The Sizewell C Project

9.126 SZC Co. Response to Request for Further Information at Deadline 10 (6 October 2021)

Table 2.1: SZC Co Response to ExA’s Request for Further Information

Plate 1- Revised Early year HDV profile with vehicle types

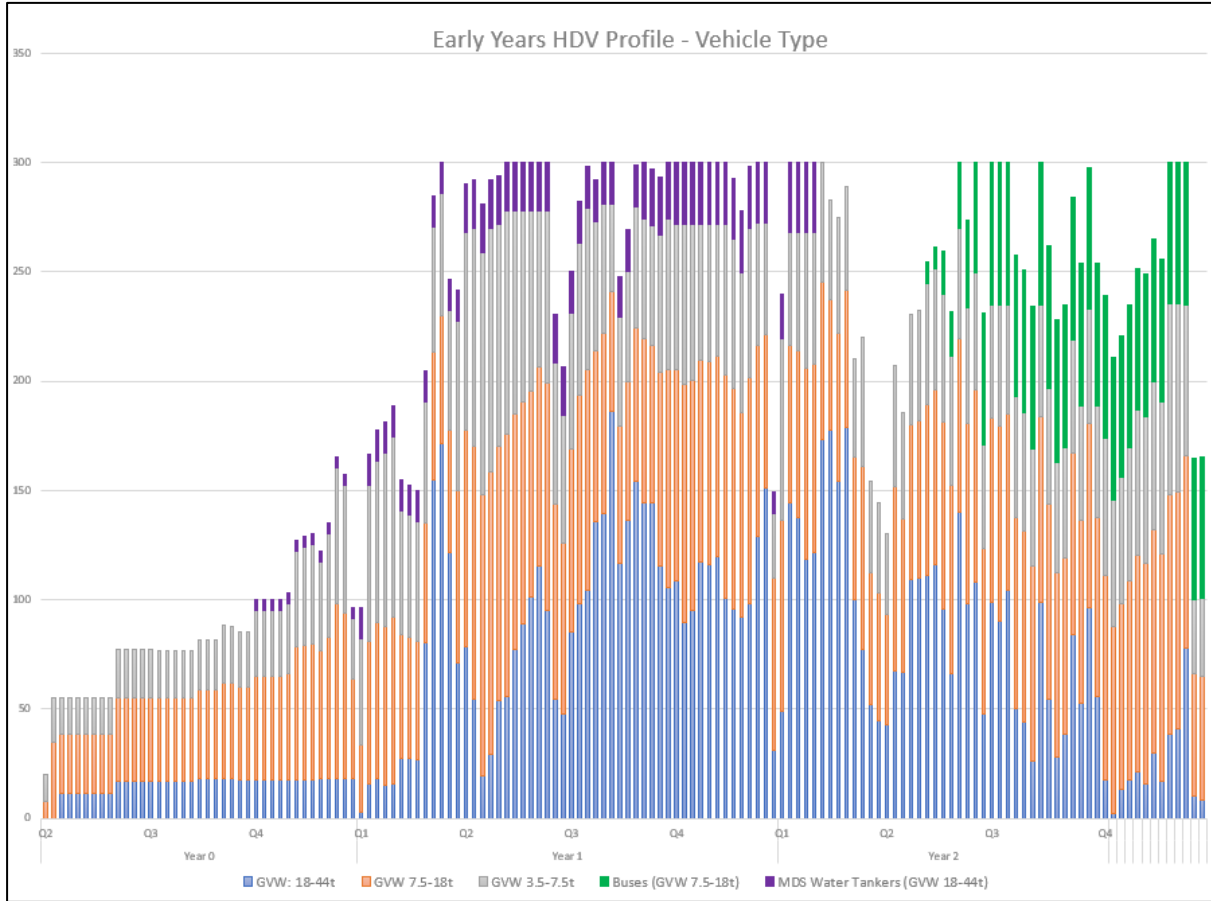
“The histogram in paragraph 1.9.2 [REP7-071] shows a smoothed HDV profile. It is not possible from this to ascertain any precise details. Provide an update to Figure 1 (The Early Years) of the Material Imports and Modal Split [REP5-114] that clearly annotates the smoothed HDV profile provided at Deadline 7.”

- i. HGV by size as previously in Figure 1 [REP5-114];*
- ii. Water tankers; and*
- iii. Buses”*

1.2.1 A revised Early Years HDV vehicle type histogram has been produced at **Plate 1** below, including Year 0 Pre-commencement and enabling works. For clarity water tankers and buses that will route down the B1122 to the MDS are shown separately, however these would represent gross vehicle weight (GVW):18-44t and GVW:7.5-18t type vehicles respectively.

1.4.1 The revised Early Years HDV profile, **Plate 1** above, has been updated to show:

- Vehicle movements by type/ size
 - GVW 18-44t
 - GVW 7.5-18t
 - GVW 3.5-7.5t
- Buses. These were excluded in the Figure 1 [REP7-071] version but have now been added. These are GVW 7.5-18t type vehicles but shown separately for clarity.
- Water tankers, which are GVW 18-44t type vehicles have been shown separately for clarity.
- Cars and LGVs (GVW <3.5t) are not shown on the histogram as they do not count towards the HDV/HGV movements caps.

Plate 2 – Early Years HDV Profile

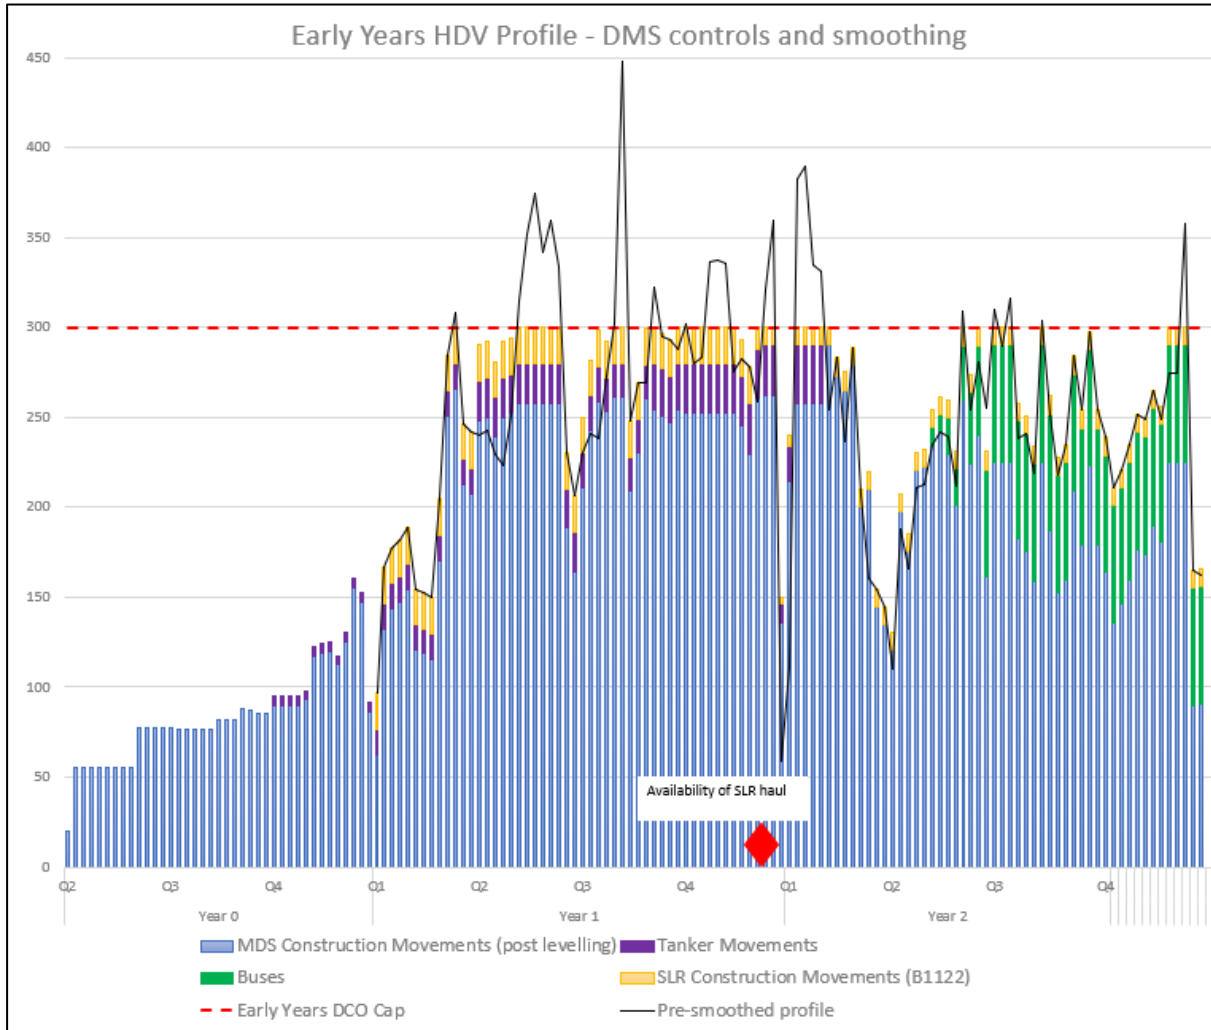
“Additionally, it is noted that in the latest version of the Implementation Plan / Phasing Schedule there are a number of activities, including the desalination plant construction that start in Year 0 and HDV flows in Year 0 should be included in the Early Years assessment.”

1.3.1 These Year 0 - Pre-commencement and Enabling works movements and the corresponding Relocated Facilities movements have been added to the HDV vehicle type histogram in **Plate 1** above and **Plate 2** in the Early Years HDV profile narrative below.
